**Maine Maritime Academy  
Castine, Maine**

**Pier Upgrades and Waterfront Improvements Project  
March 1, 2024  
ADDENDUM NO. 3**

**STMH-1 - STRUCTURAL ISOMETRIC**  
SCALE: N.T.S.

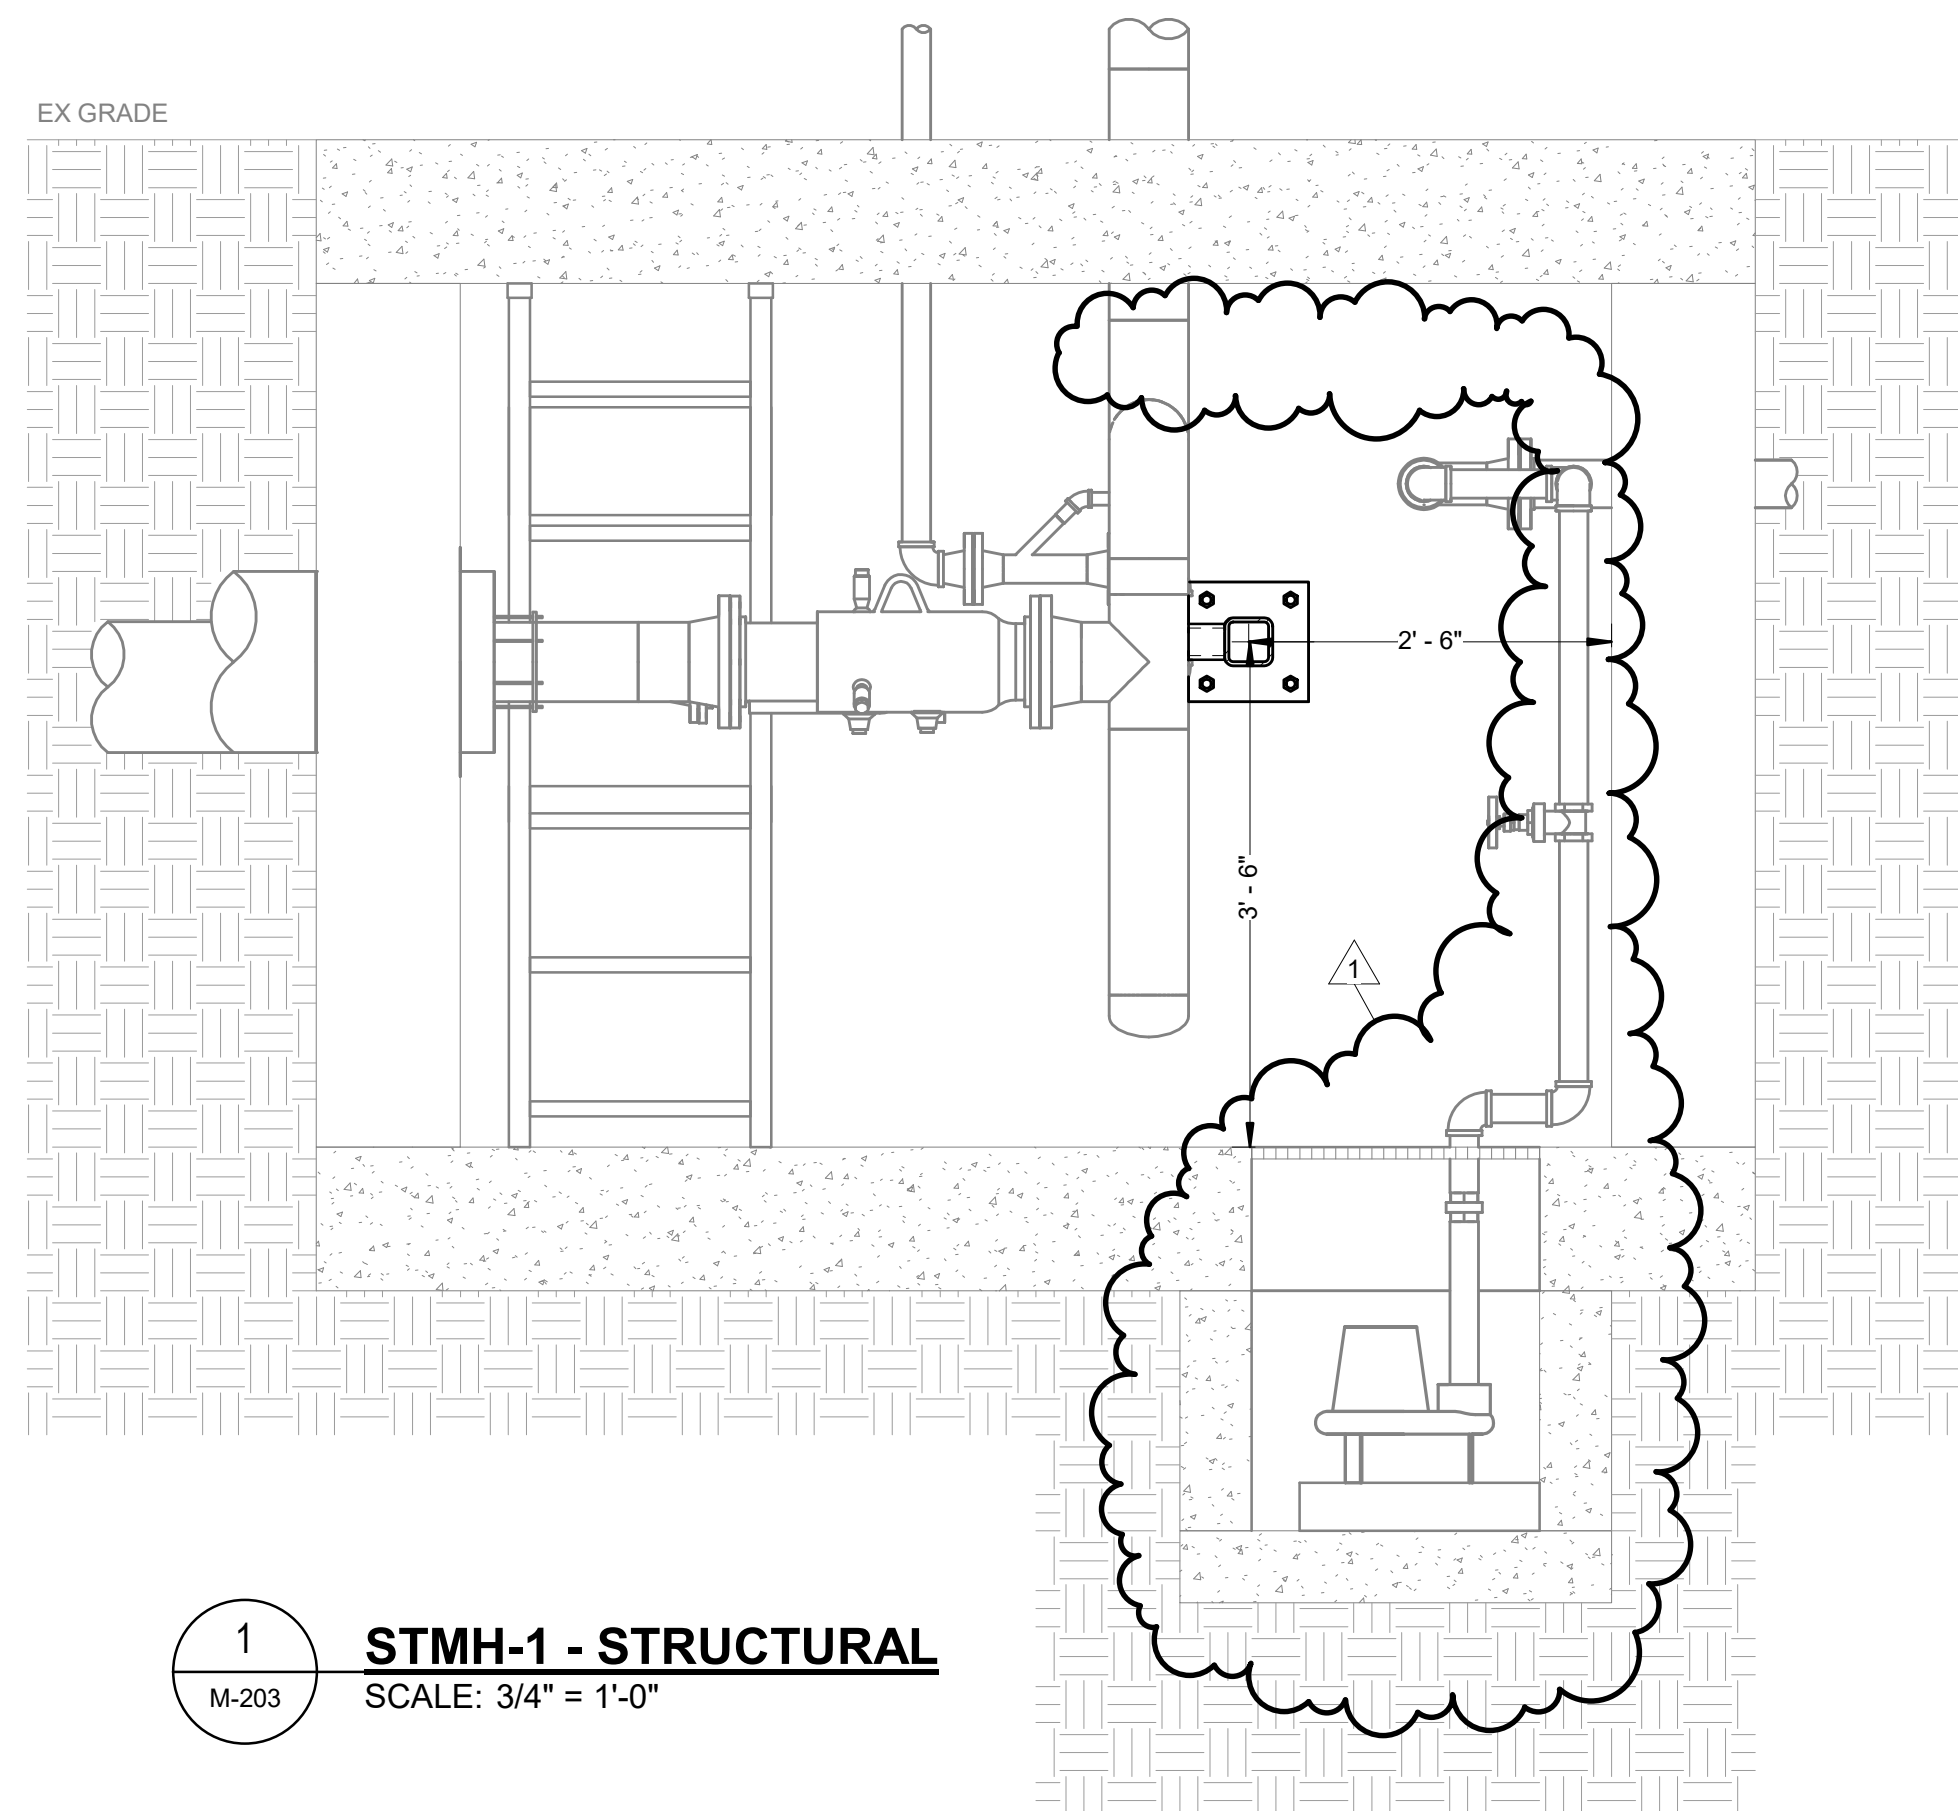
17. M-203 Steam Vault – New Work – Structural
  - a. Changed the sump pump in vault STMH-1 to an electric type, and made the sump pit more shallow.
18. M-204 mechanical Trench Plan – New Work

**TRENCH PLAN A**  
SCALE: 3/16" = 1'-0"

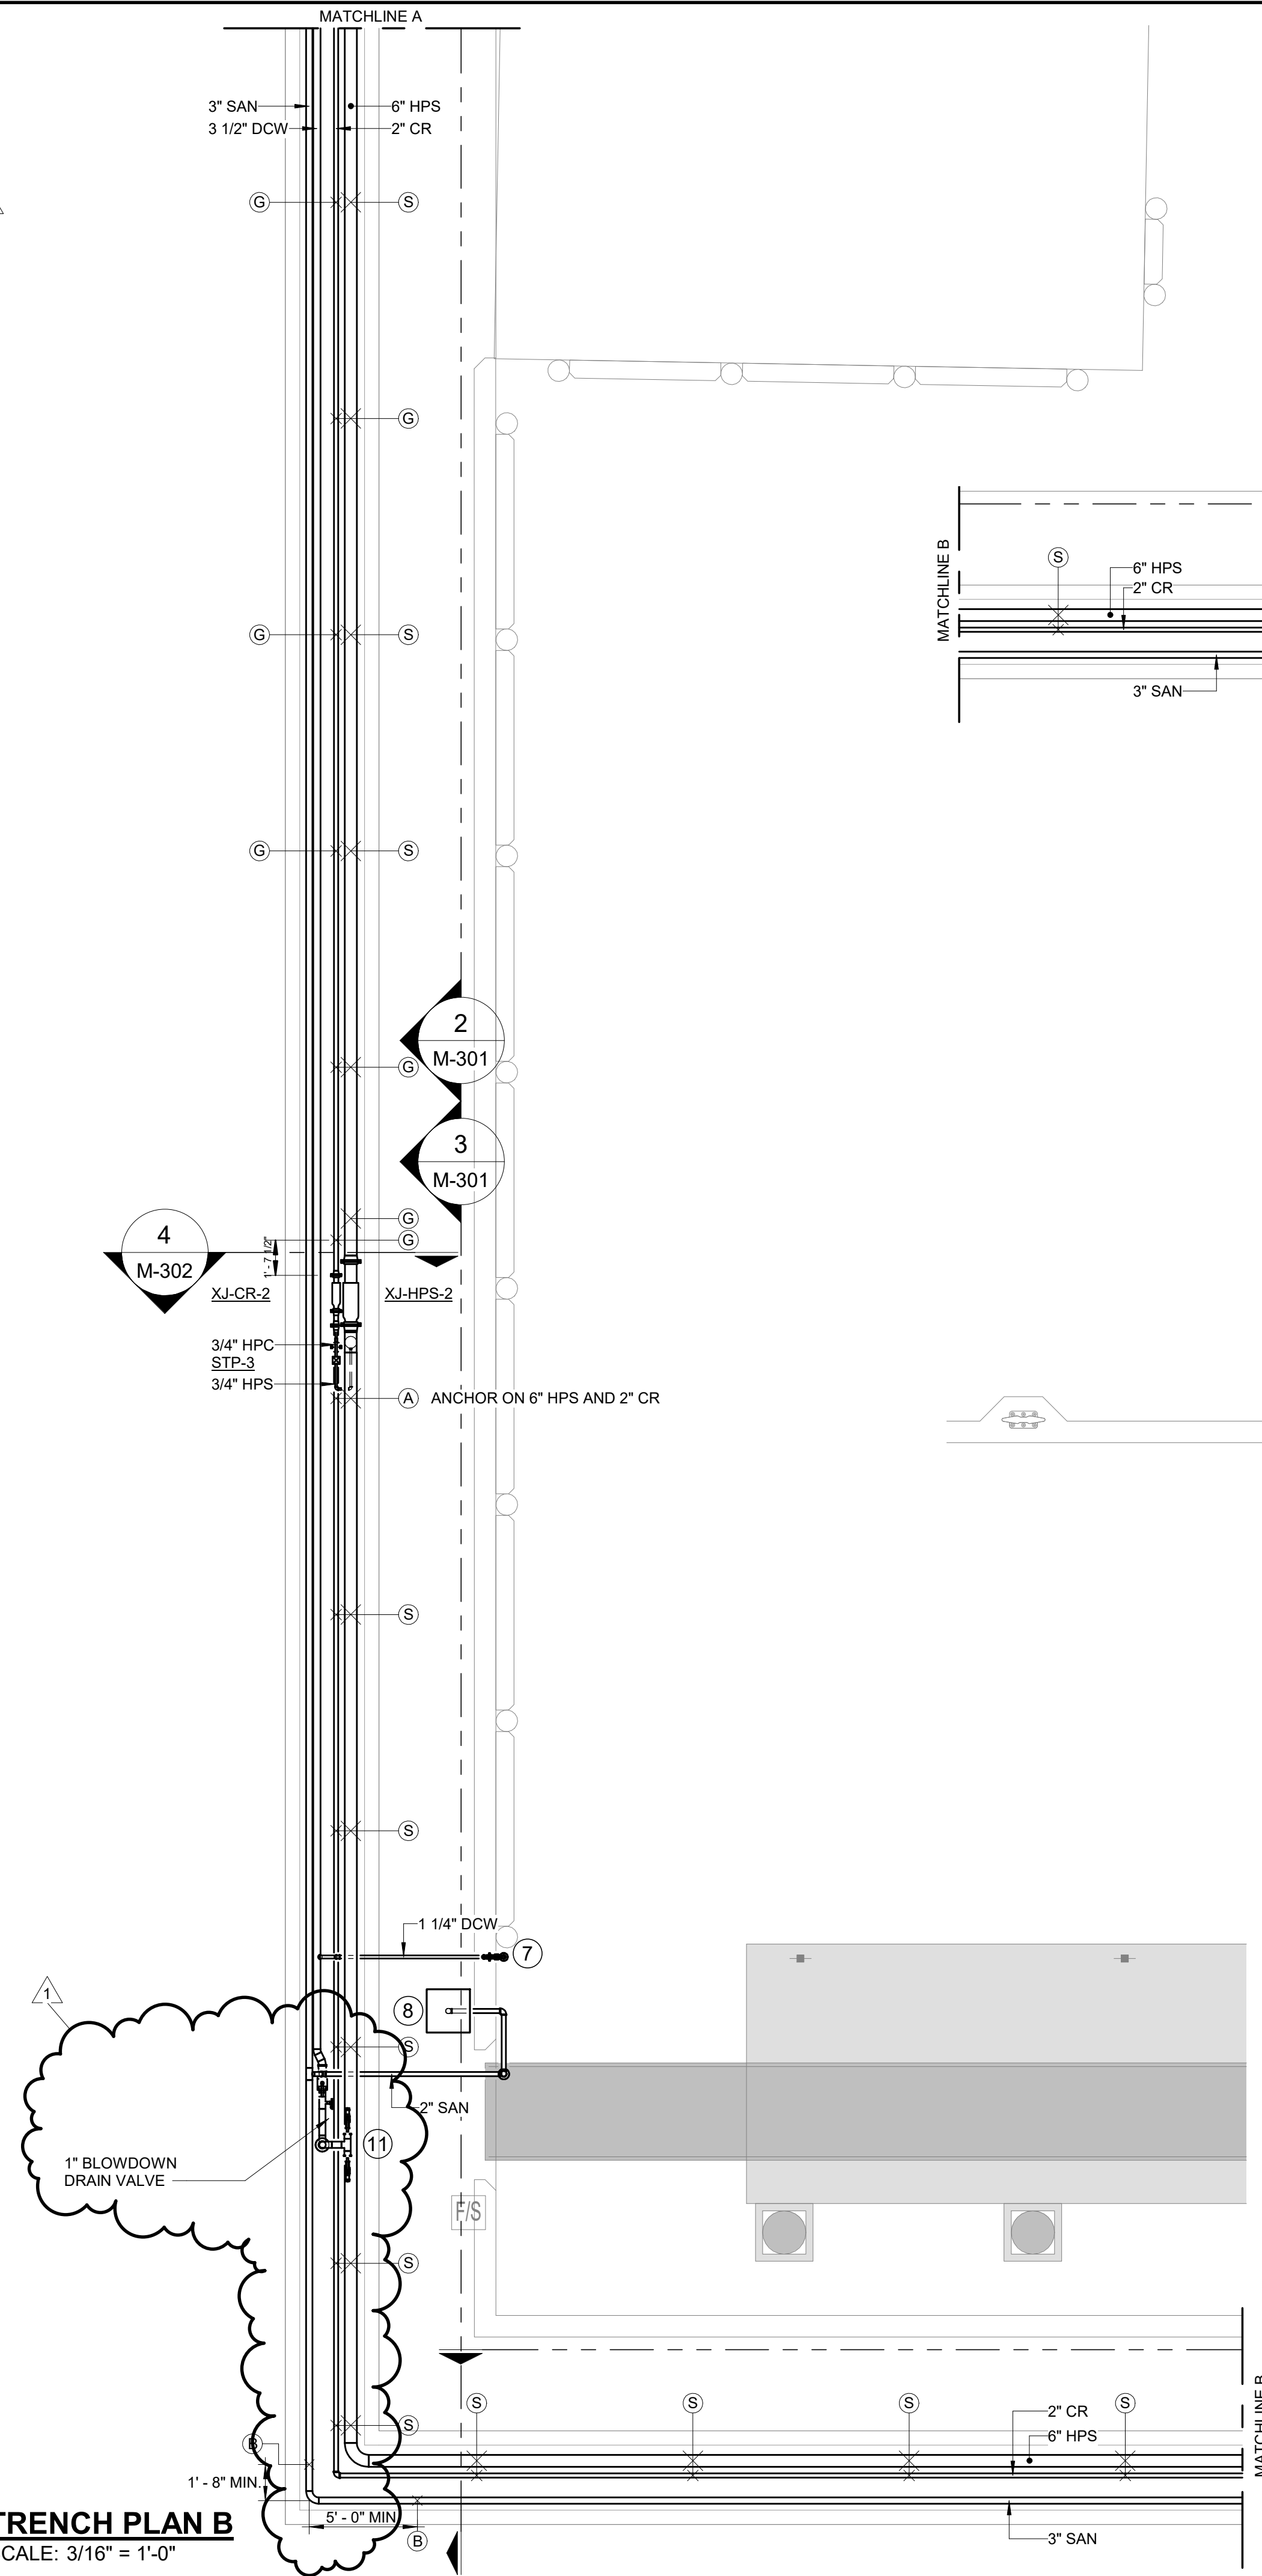
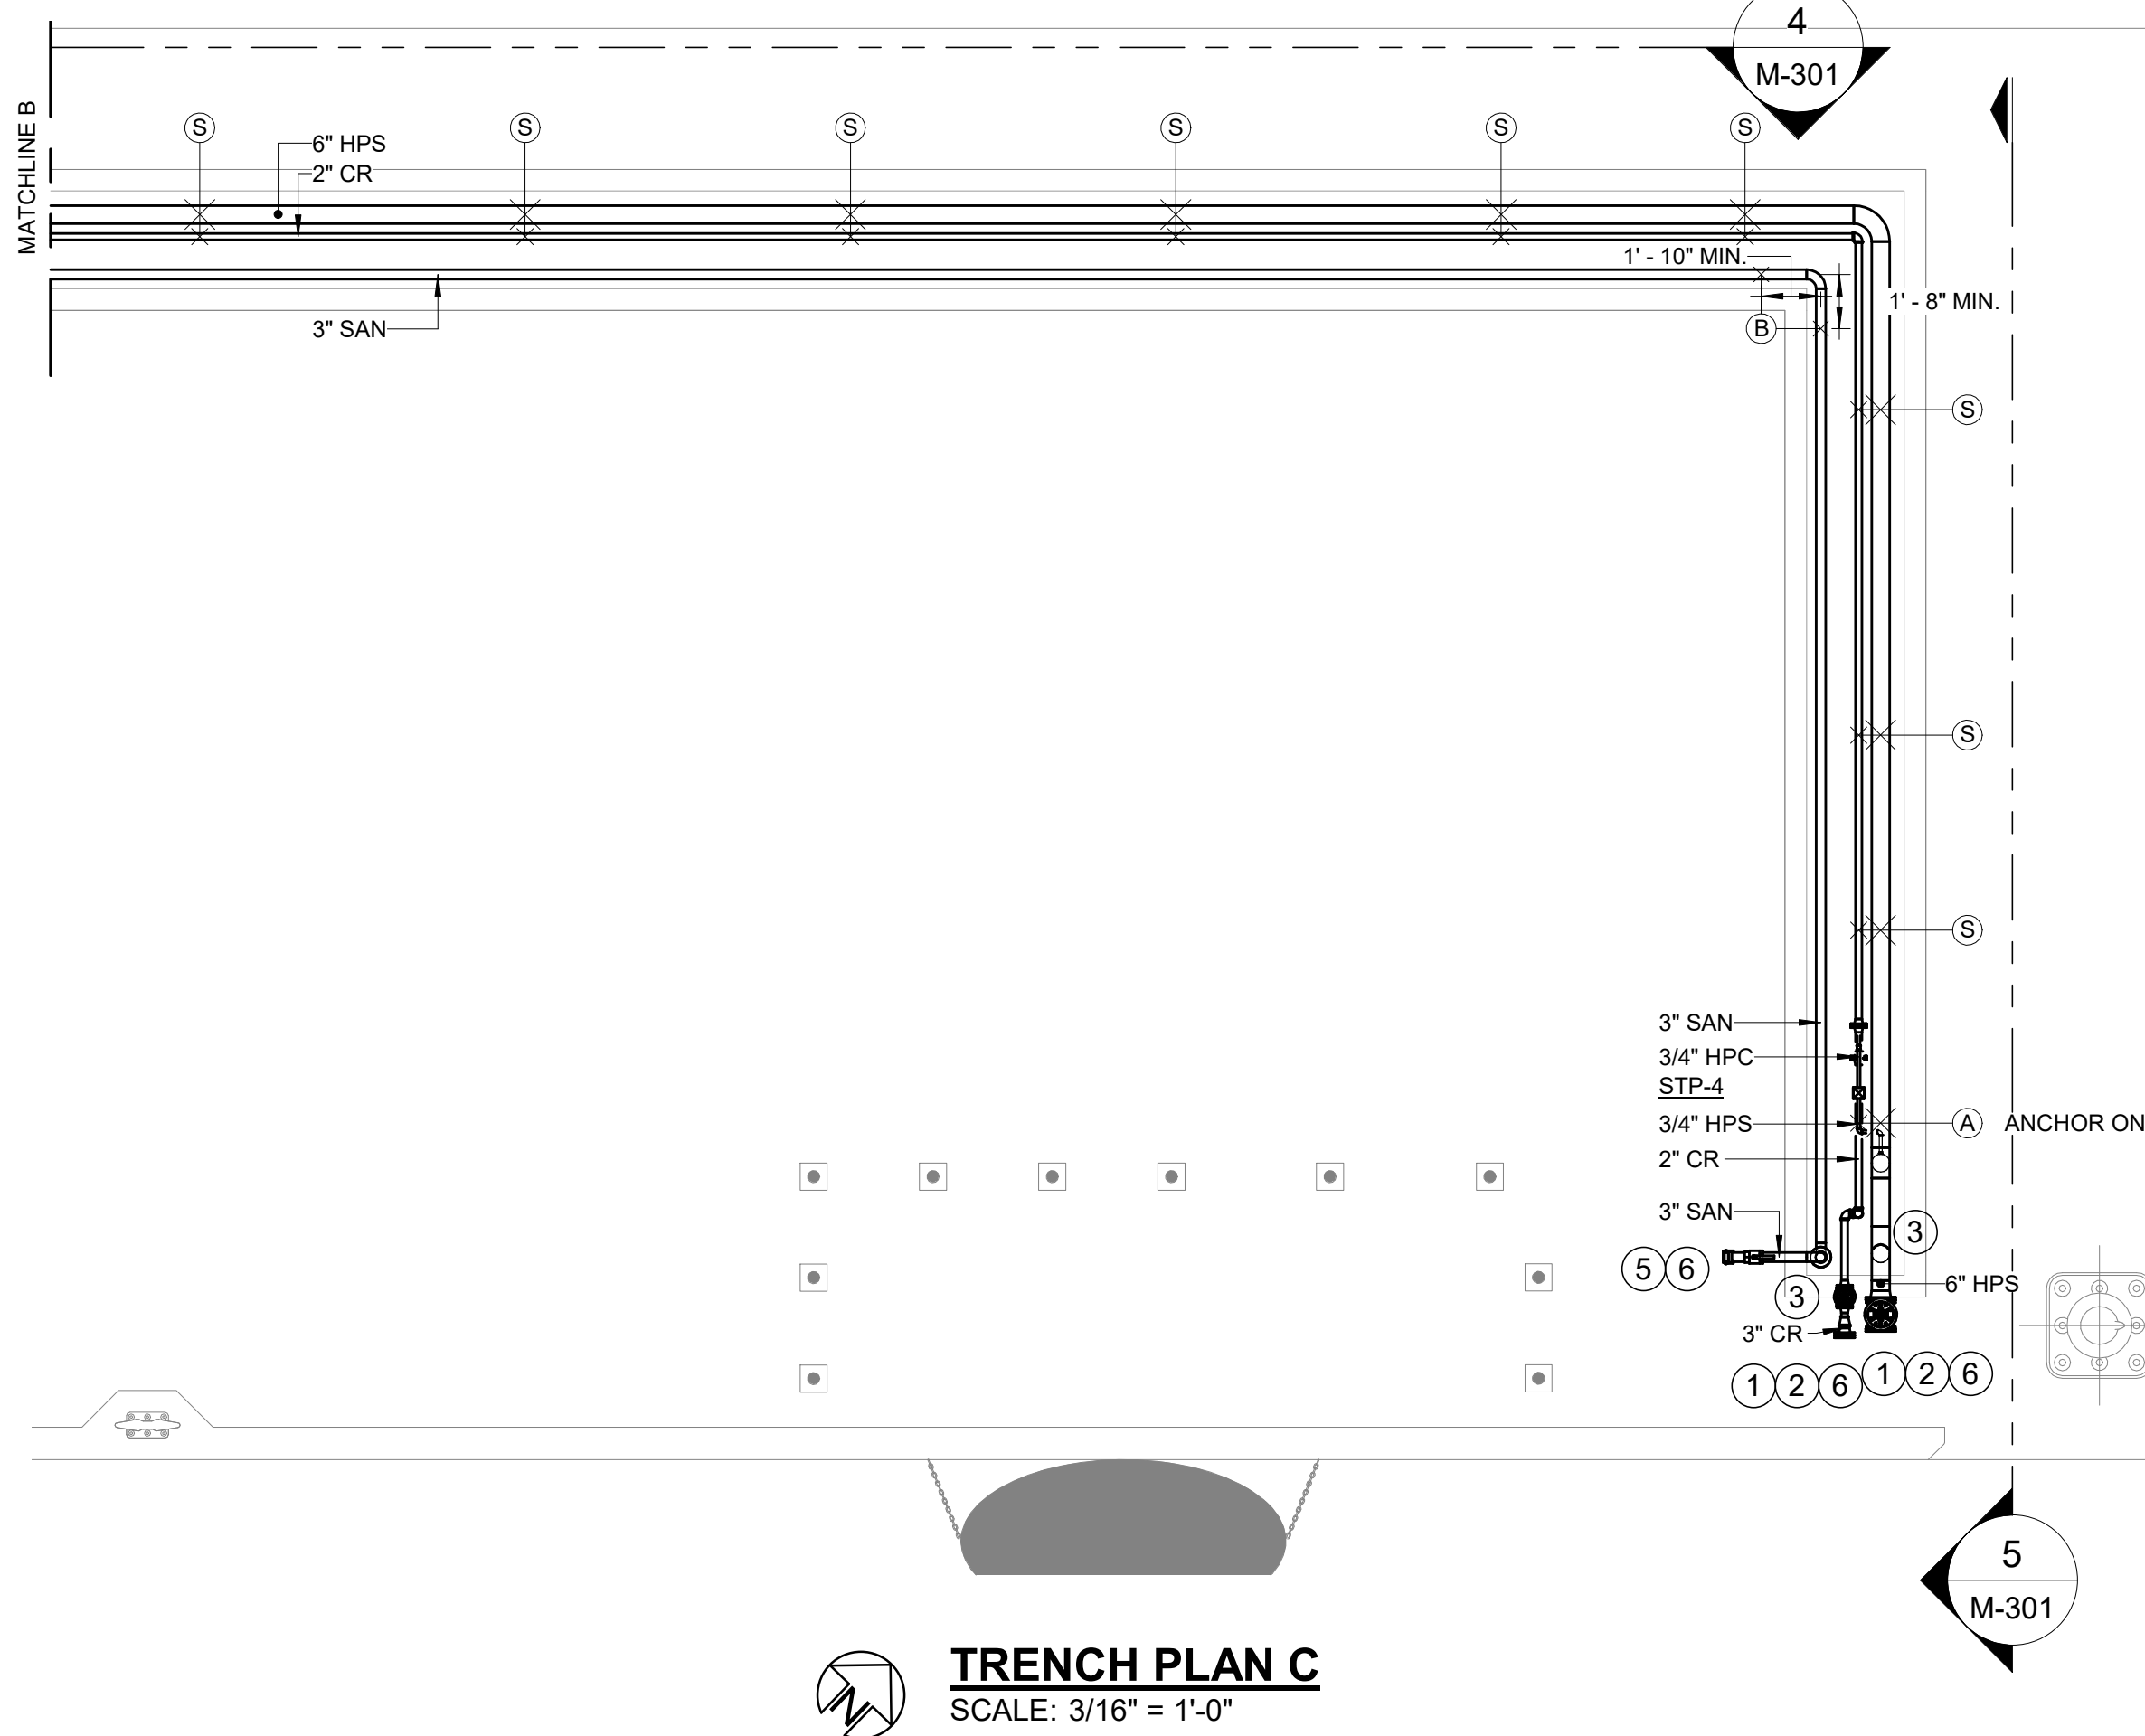
- a. Added (2) 3” ball valve, and (2) 1” blowdown/drain valves to the DCW line in the utility trench.
  - b. Showed the new location for the DCW pipe termination for the ship’s connections.
